### **PRODUCT CHANGE NOTIFICATION**

# **Bourns® Model SRR1210A Series Shielded Power Inductors**

## **Gluing Position Change**

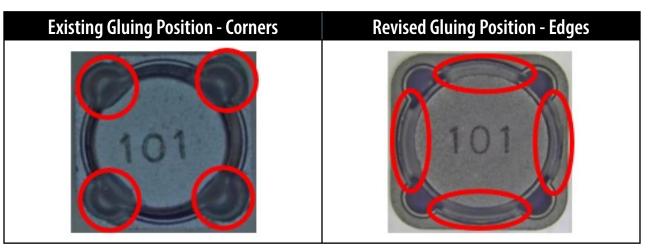
*Riverside, California* – May 6, 2024 – In the spirit of continuous improvement, effective July 30, 2024, Bourns will change the gluing position for the Model SRR1210A Series Shielded Power Inductors from the corners to the edges to enhance their durability and reliability. A list of affected part numbers is included below.

EMEA: Tel +36 88 885 877 eurocus@bourns.com As shown in the image above, the form of the affected part numbers will change slightly due to the change in gluing position. The fit and function of the affected part numbers will remain the same. The quality and reliability of the affected inductors should be improved as a result of the change. Traceability will be maintained through lot code and date code.

Date that deliveries of products manufactured with the glue position change will begin: *July 30, 2024* First date code using the above changes: *2431*
